# Addendum No. 2

**PROJECT:** Vivie Nelson Care Center Renovation, Alexandria, MN

**From:** Wold Architects and Engineers

**Subject:** Addendum No. 2 for Bidding Documents for the
**Vivie**
**Nelson Care Center Renovation**
**Alexandria, Minnesota**

**ENLARGED PLANS - ELECTRICAL**

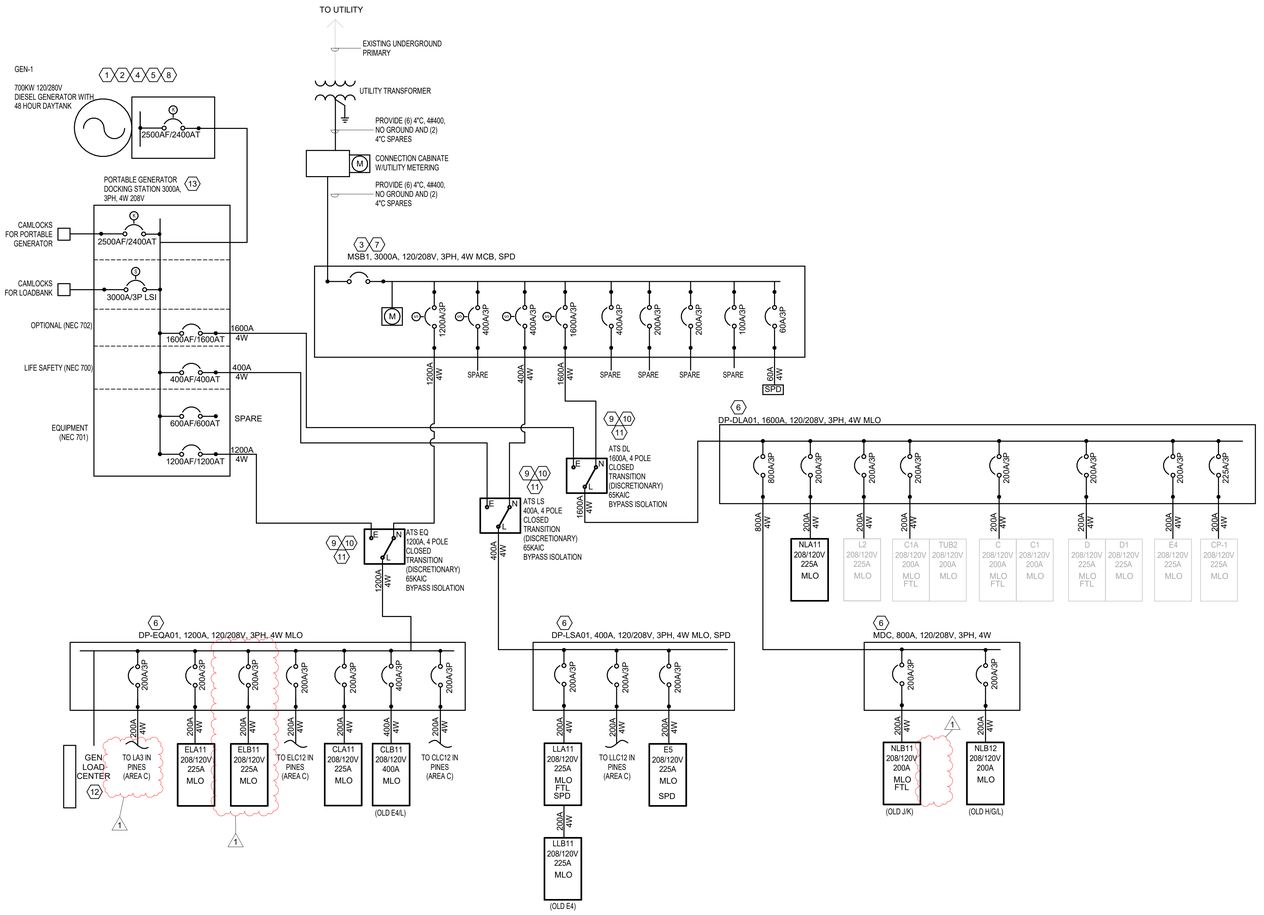
i. Addition of new plans for Care Suite and double room.

## 1 REMODELED ADMIN/SHORT STAY/MAPLES ONLINE DIAGRAM (SERVICE #1 AND #2)

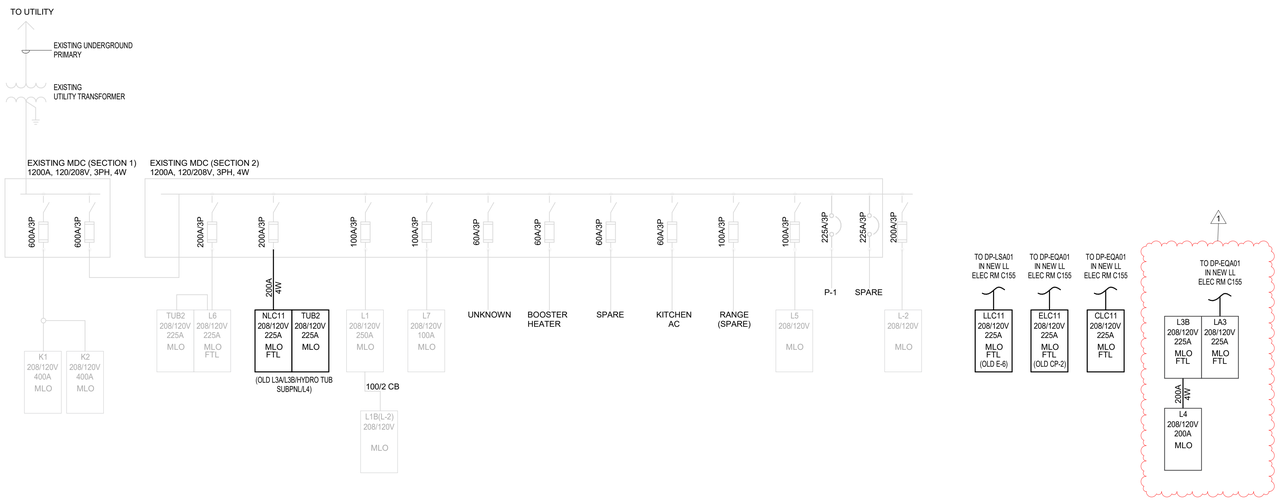
ii. Added panel ELB11

E2 TELECOM OUTLET CONFIGURATIONS
NTS

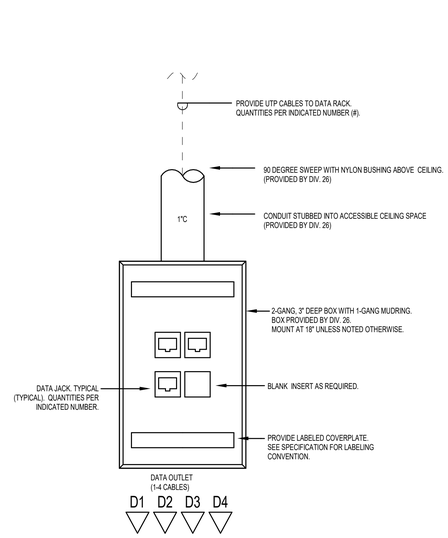
i. Revied detail E2.
